Household refrigerating appliances - Characteristics
and test methods - Part 1: General requirements

**Household refrigerating appliances - Characteristics and test
methods - Part 1: General requirements
(IEC 62552-1:2015 , modified)**

This document (EN 62552-1:2020) consists of the text of IEC 62552-1:2015 prepared by IEC/TC 59 "Performance of household and similar electrical appliances", together with the common modifications prepared by CLC/TC 59X "Performance of household and similar electrical appliances".

Figure 1 — Illustration of selected typical refrigerator operations

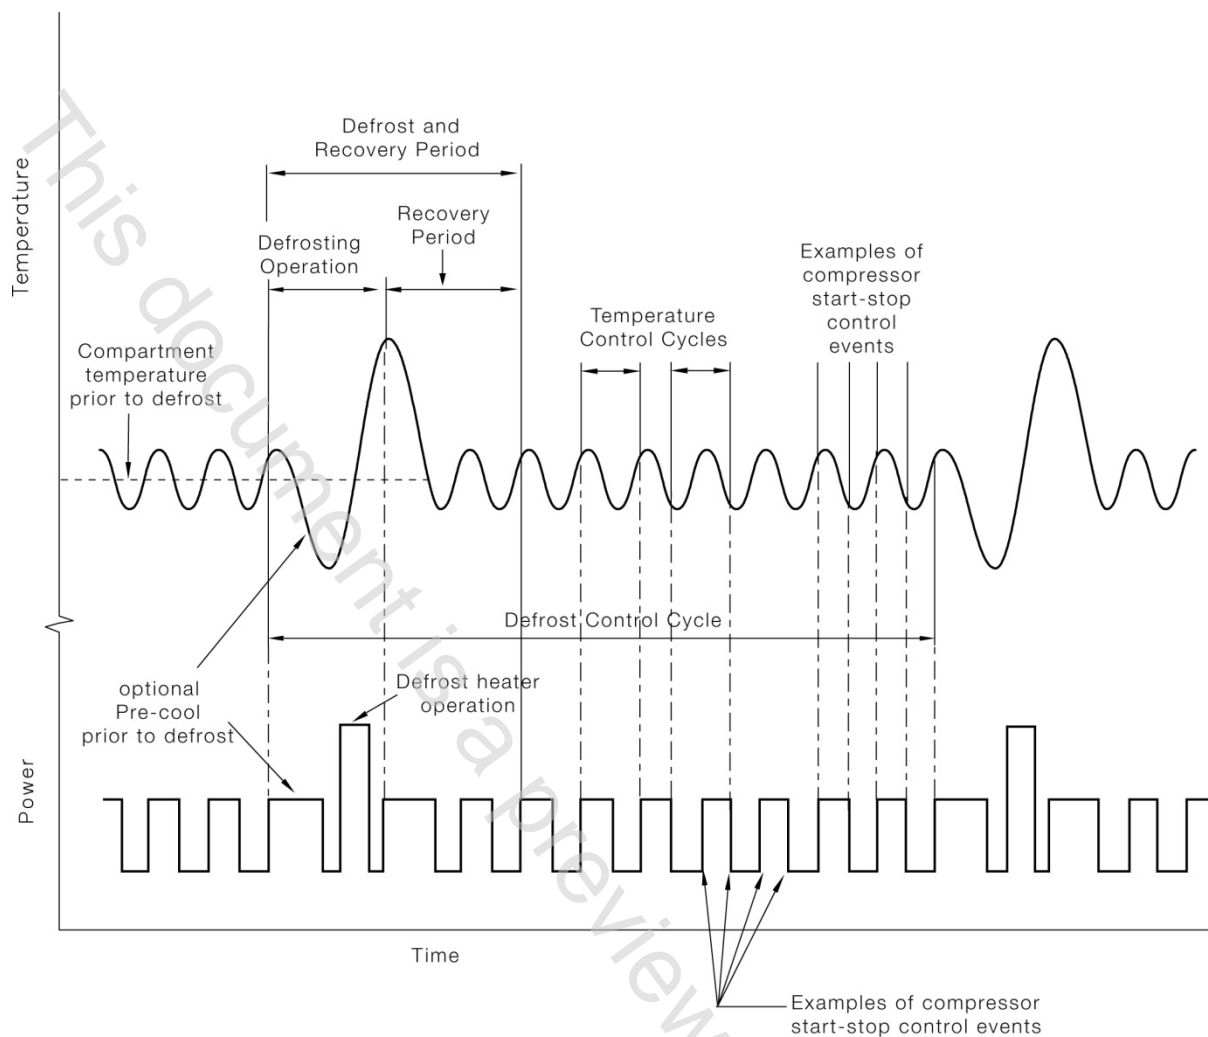
In 3.6, "Operating state as shown in Figure 1", replace Figure 1 with the following figure:

NOTE Components of refrigerator operation depicted in this figure are illustrative only and are intended to be representative of common products. Not all products will exhibit all features and some products may operate in a different manner. Written definitions have precedence over depictions in this figure.
